Access Compliance Report

Public Rights-of-Way

(Curb Ramps)

Intersection ID: 20694	Main Street: LONG_MEADOW_RD	Cross Street: STOKES_AV	Location: NE
ADA ID: C4E3F65648F6	Ramp Type: PerpDiag	Initial Pass/Fail: Fail	Overall Compliance: No
Codes/Mitigation Info/Possible Solution			Severity Score: 22.5
			Field Measurements/Component Compliance

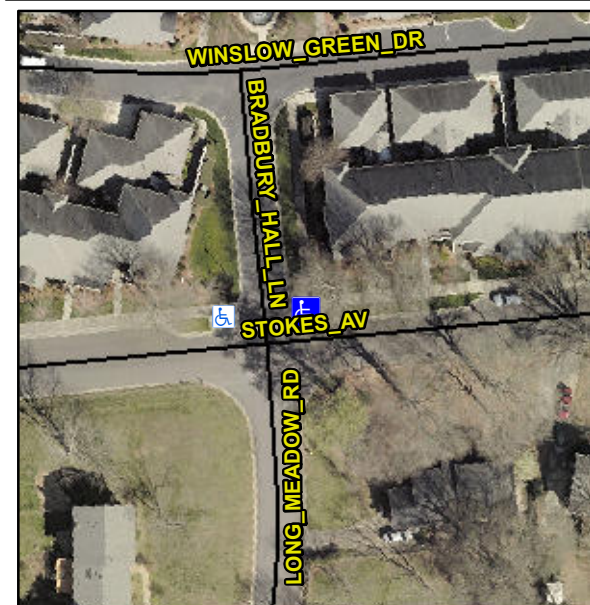
Not Found, R304.5.1, R304.2.2, R304.5.3

Compliance	Description	Data	Compliance	Description	Data
N/A	Ramp Length (in)	77.0	No	Ramp Slope (%)	8.6
No	Ramp Width (in)	36.0	No	Ramp XSlope (%)	3.9
N/A	Flare Type LT	N/A	N/A	Flare Type RT	N/A
N/A	Flare Slope LT (%)	N/A	N/A	Flare Slope RT (%)	N/A
N/A	Flare Traversable LT?	N/A	N/A	Flare Traversable RT?	N/A
N/A	Landing Length (in)	N/A	N/A	DWS Provided?	N/A
N/A	Landing Width (in)	N/A	N/A	DWS Contrast?	N/A
N/A	Landing Slope (%)	N/A	N/A	DWS Length (in)	N/A
N/A	Landing X Slope (%)	N/A	N/A	DWS Full Width?	N/A
N/A	Landing Curb? (Y/N)	N/A	N/A	DWS Offset (in)	N/A
N/A	Shared Landing?	N/A			
N/A	Gutter Ponding?	N/A	N/A	Gutter Slope (%)	N/A
N/A	Gutter Lip Ht (in)	N/A	N/A	Gutter X Slope (%)	N/A
N/A	Painted X Walk1?	No	N/A	Painted X Walk2?	No
	X Walk 1 Direction	To W		X Walk 2 Direction	To S
N/A	X Walk 1 Width (in)	N/A	N/A	X Walk 2 Width (in)	N/A
	X Walk 1 Slope (%)	2.4		X Walk 2 Slope (%)	4.3
	X Walk 1 X Slope (%)	1.2		X Walk 2 X Slope (%)	1.6

Remove & Replace Curb Ramp With Two New Directional Ramps or Equivalent.
